## Product Change Notification / LIAL-15QPNY176

CCB 4506 Initial Notice: Qualification of MMT as an additional assembly site for selected products available in 8L TDFN (2x3x0.8mm) package.

**CCB 4506**  
**Pre and Post Change Lead Frame Comparison**  
**PCN # LIAL-15QPNY176**

# Lead frame comparison

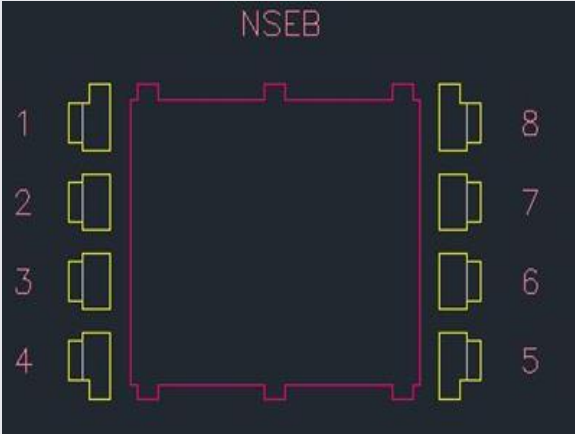
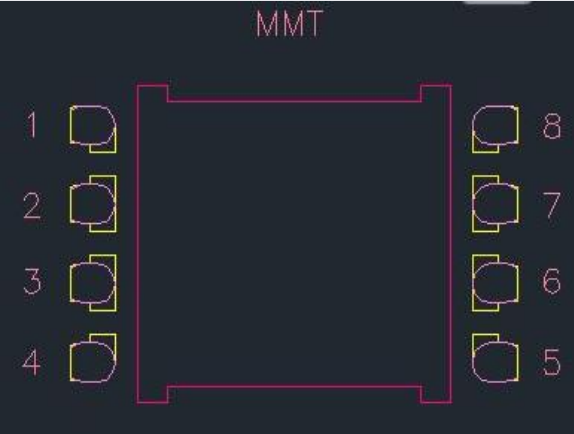
Assembled at NSEB using gold (Au) bond wire or palladium coated copper with gold flash (CuPdAu) bond wire, 8200T die attach or 8600 die attach material and with lead-lock lead frame.

Assembled at NSEB using gold (Au) bond wire or palladium coated copper with gold flash (CuPdAu) bond wire, 8200T die attach or 8600 die attach material with lead-lock lead frame or assembled at MMT using palladium coated copper with gold

flash (CuPdAu) bond wire, 3280 die attach material and without lead-lock lead frame.

|                                  | Pre Change                                |        | Post Change                               |        |                                                          |
|----------------------------------|-------------------------------------------|--------|-------------------------------------------|--------|----------------------------------------------------------|
| <b>Lead Frame Lead Lock</b>      | Yes                                       |        | Yes                                       |        | No                                                       |
